EPC STORMWATER REVIEW COMMENTS IN ORANGE BOXES WITH BLACK TEXT

OVERALL ALTERNATIVE LANDSCAPE PLAN

The Shire At Old Ranch
Howells & Old Ranch Road
Colorado Springs, CO

LS 1

LS 2

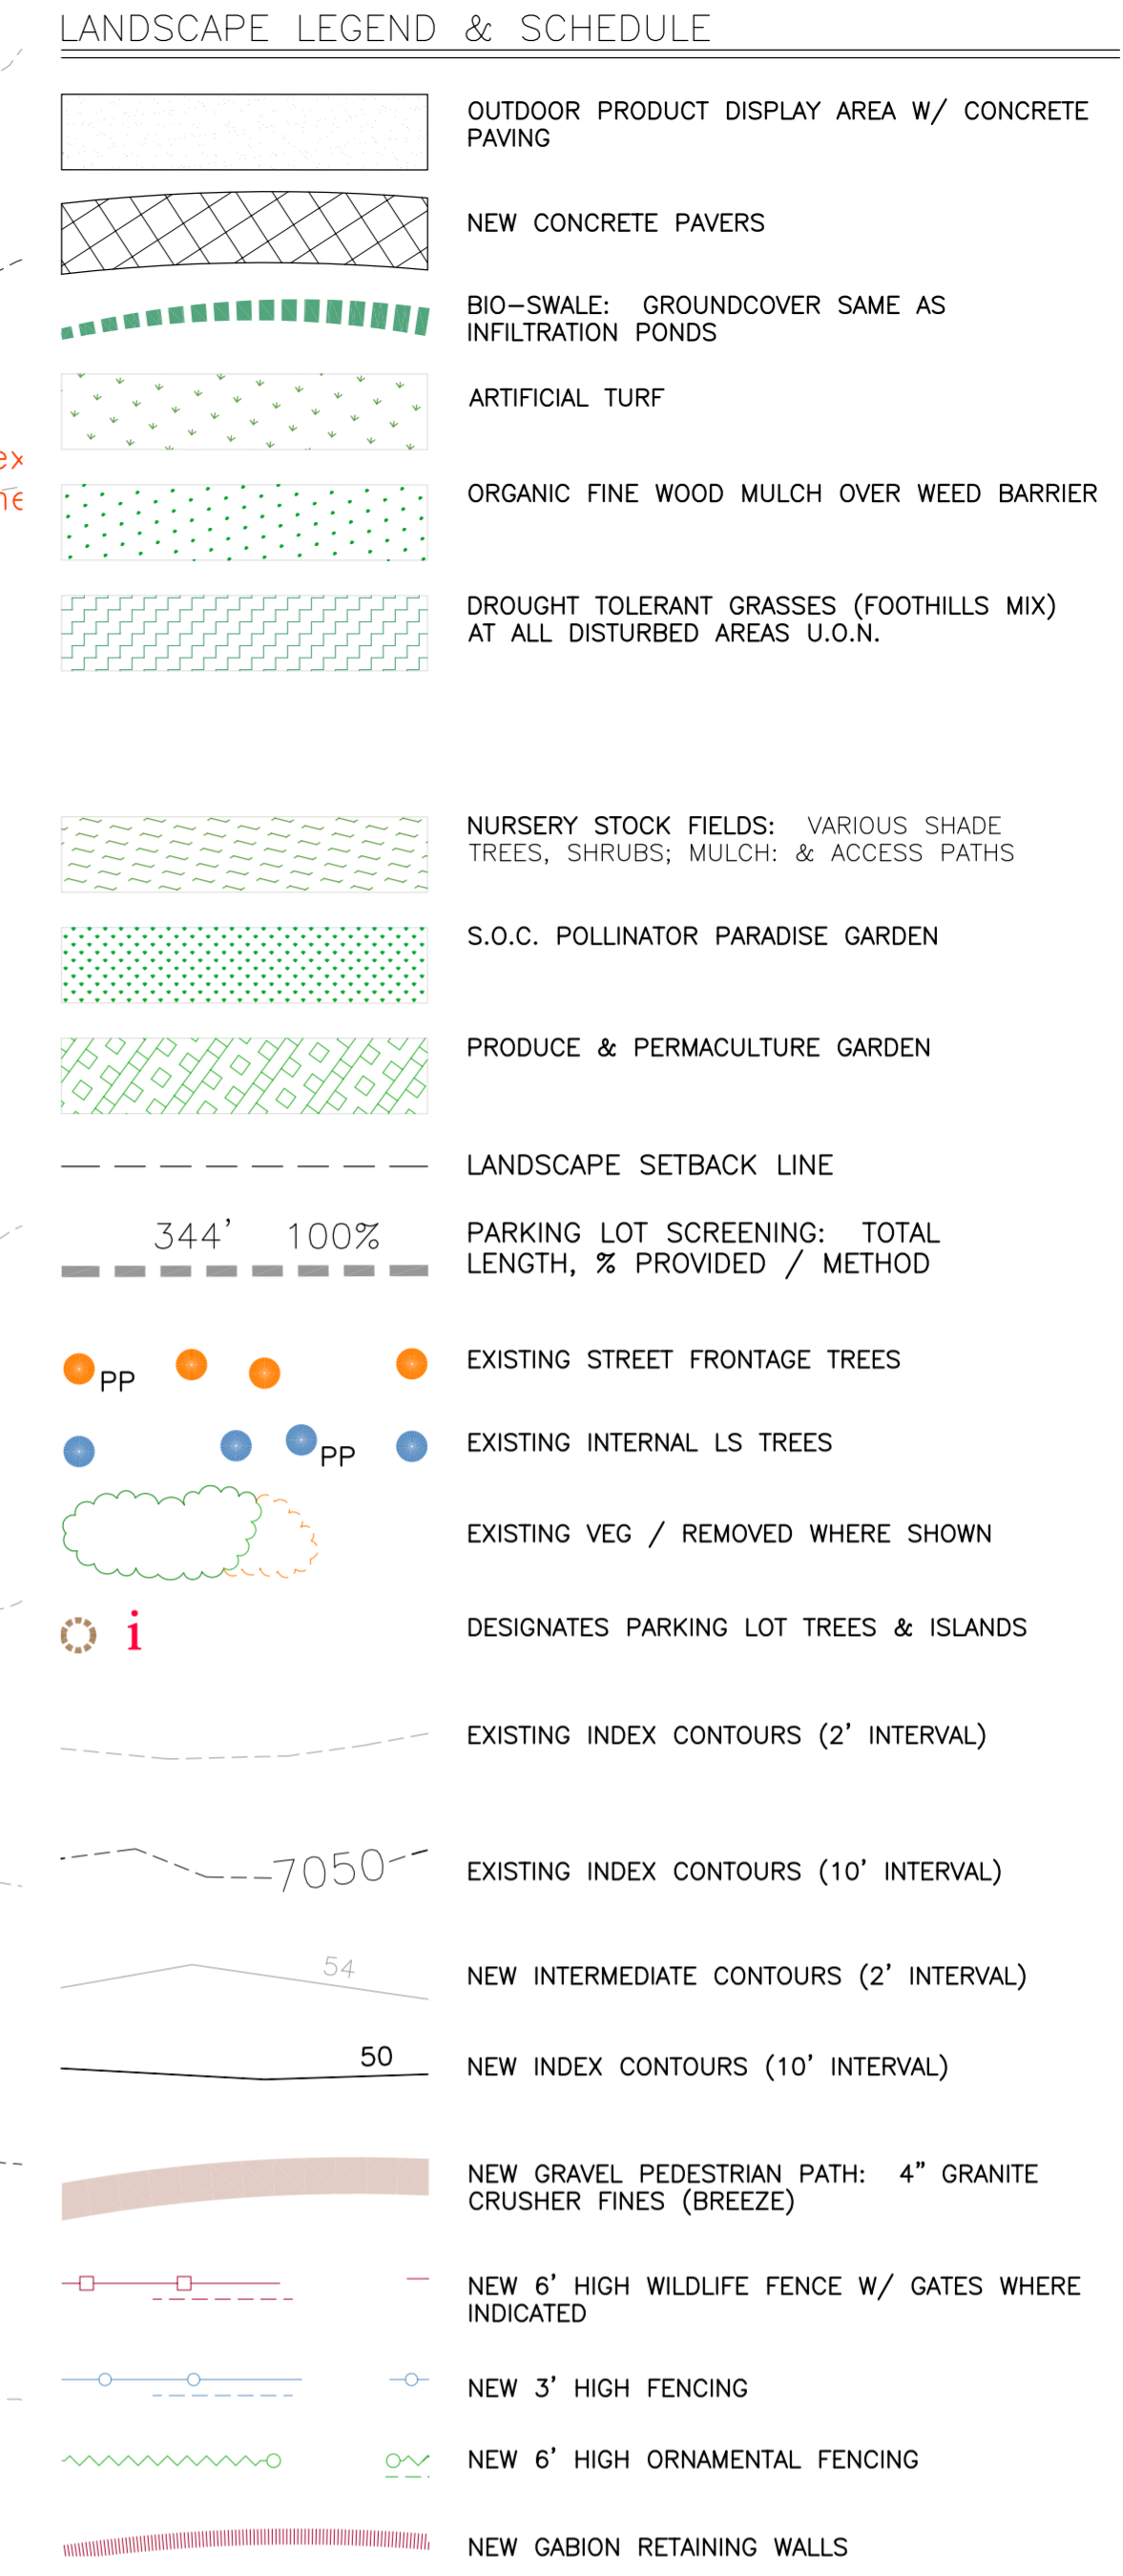
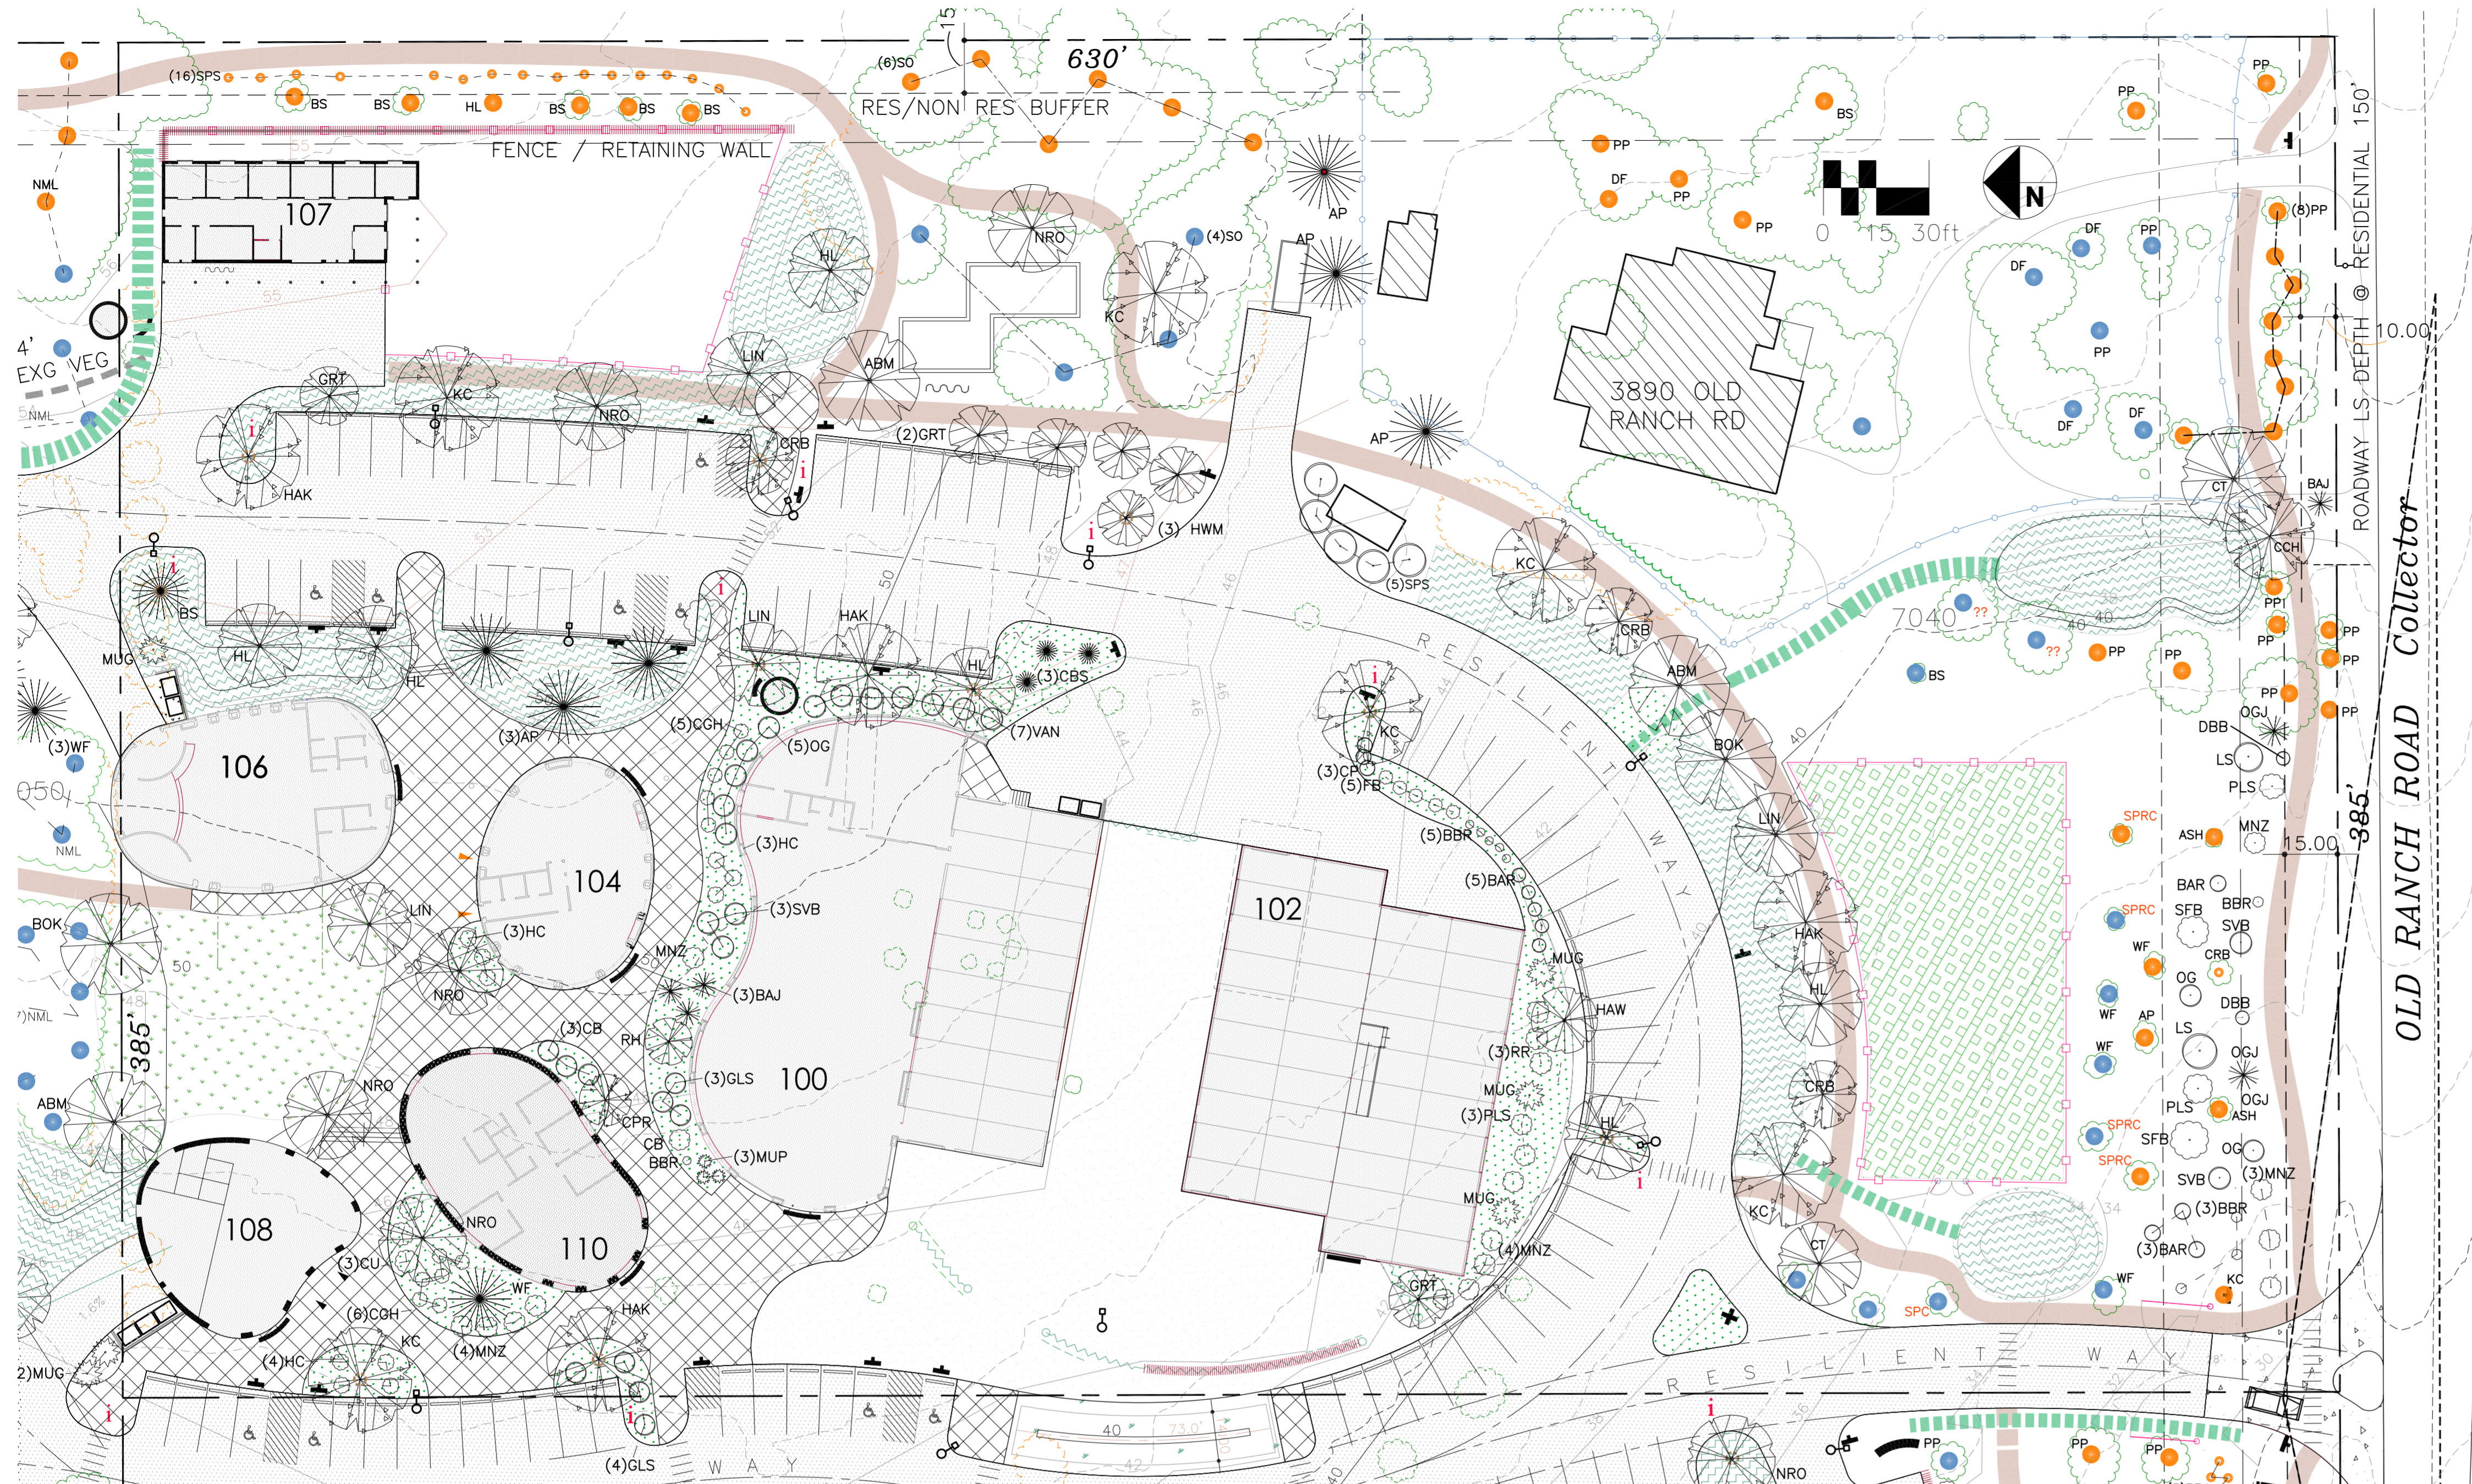
This type of tree is not recommended per the landscape code, please consider planting a different species, what is existing is fine

LS 4

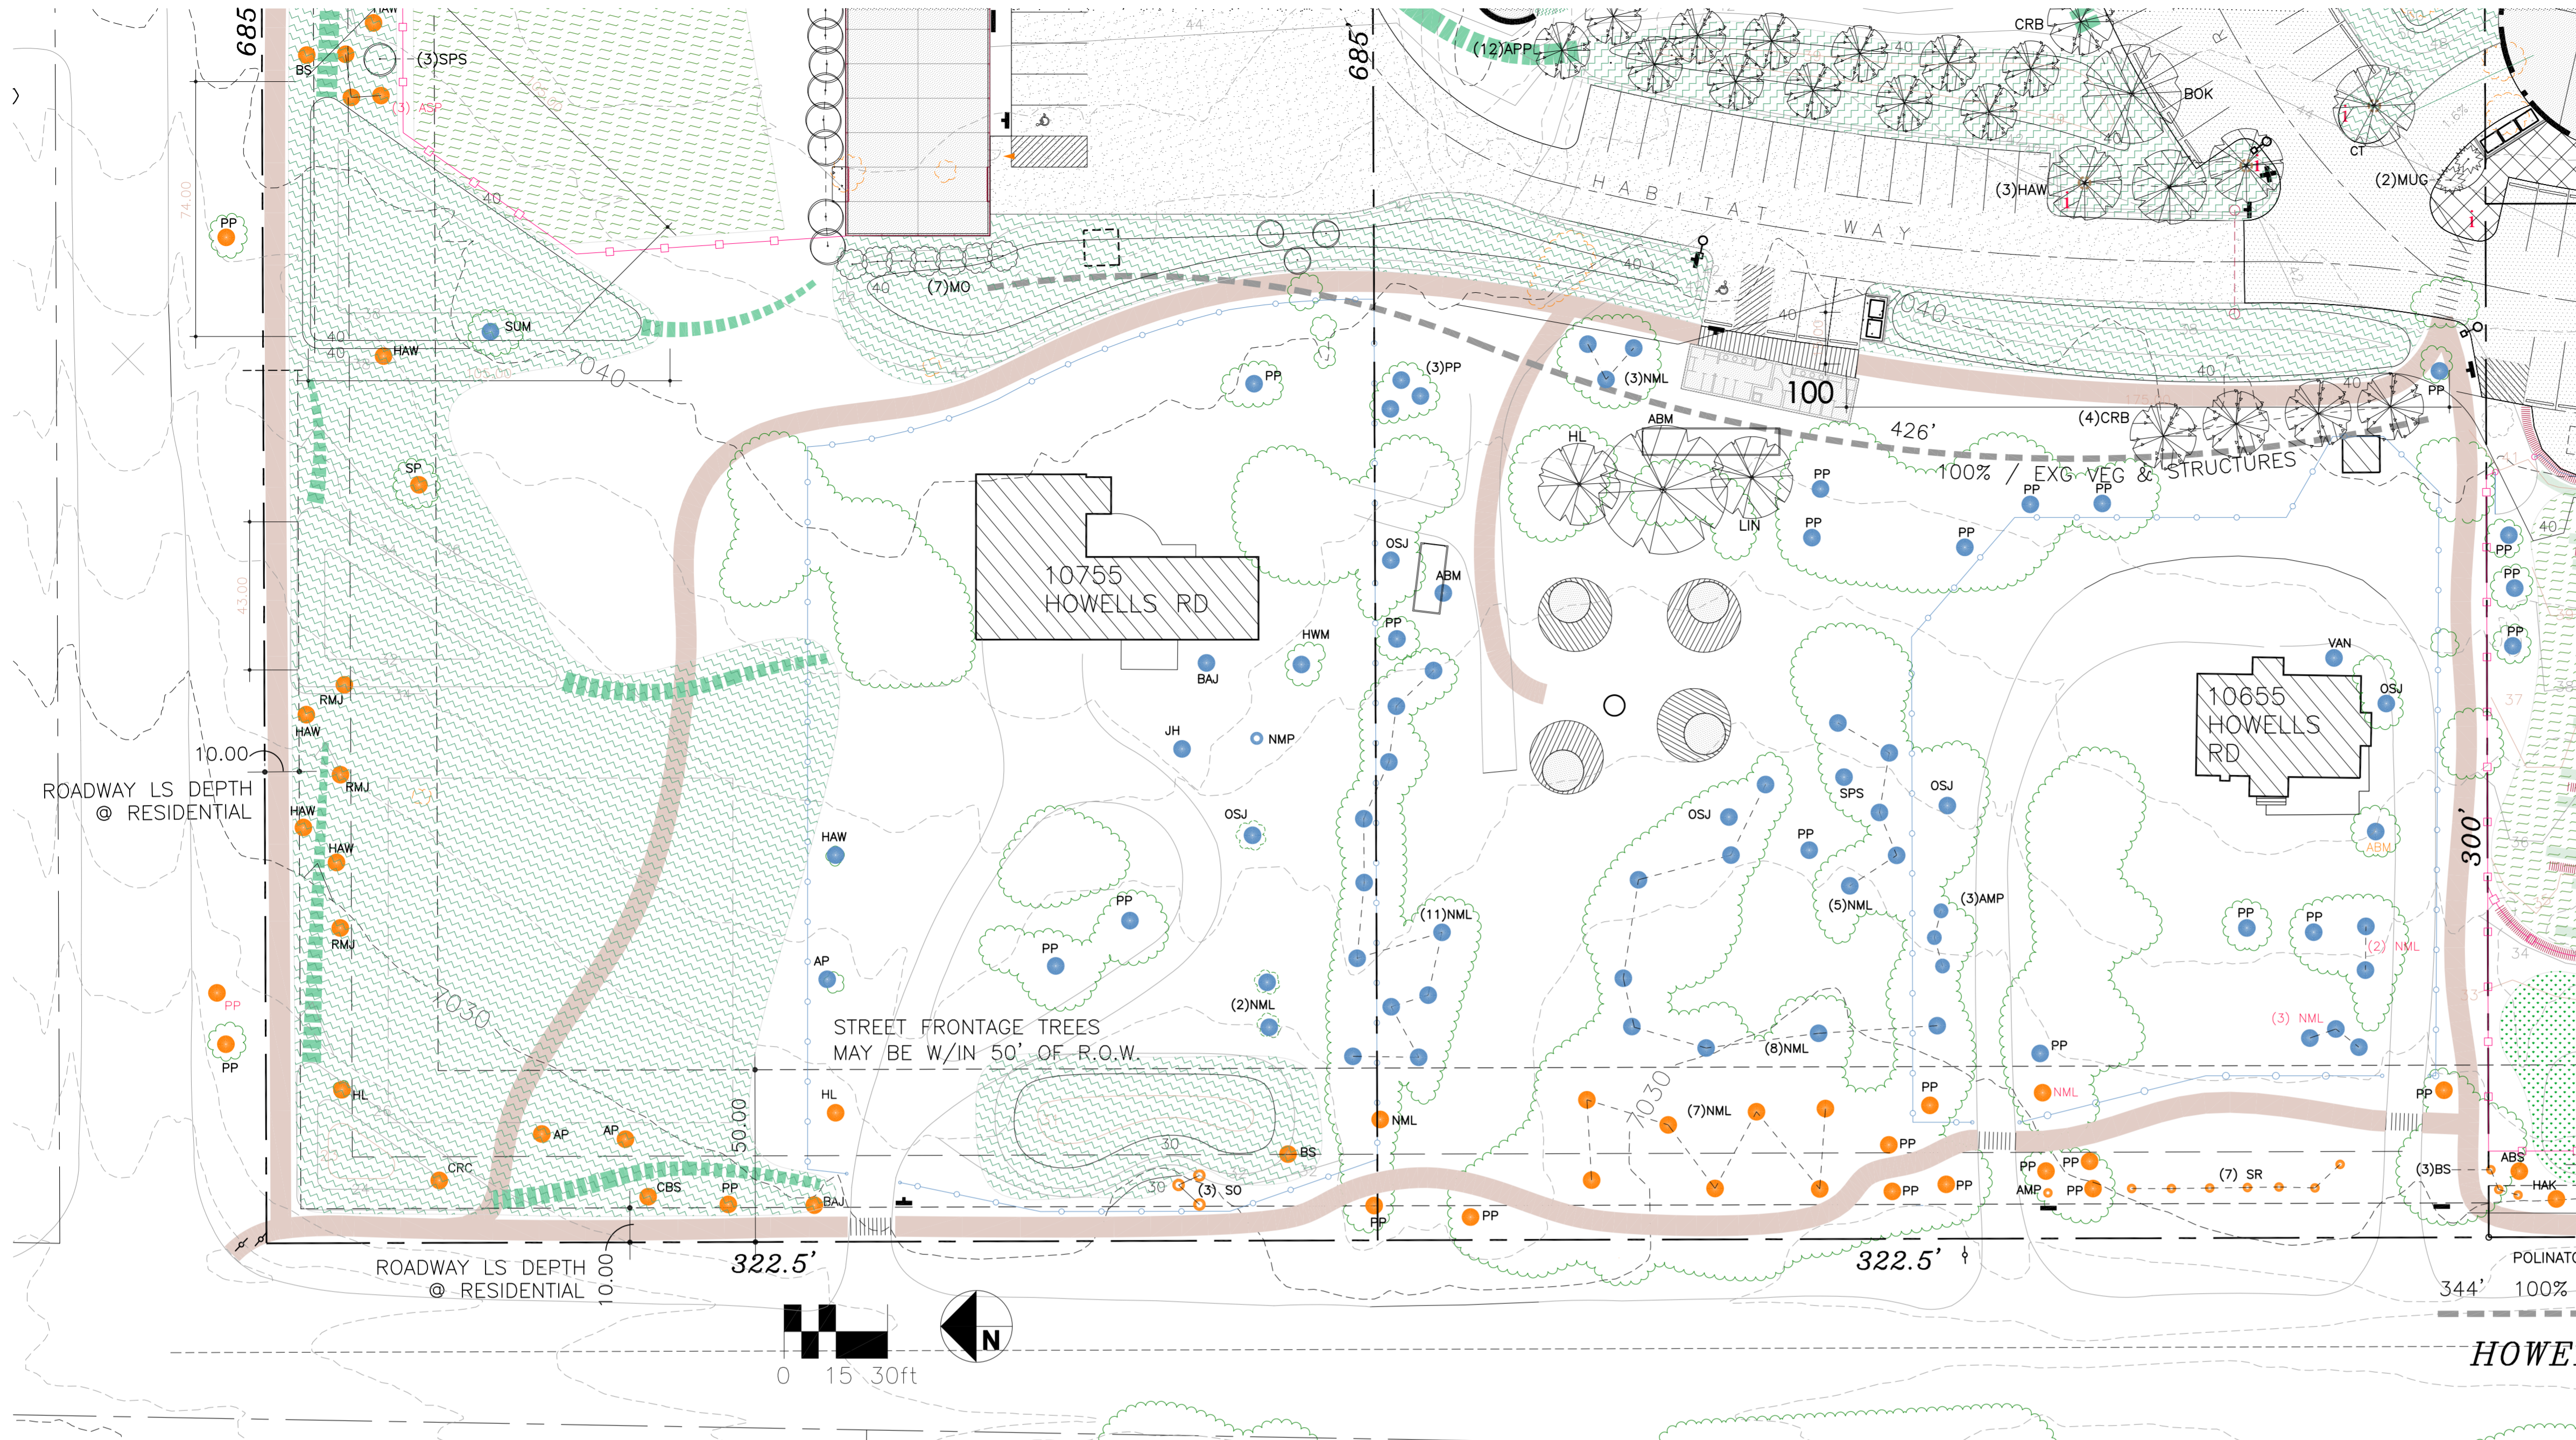
This type of tree is not recommended per the landscape code, please consider planting a different species, what is existing is fine
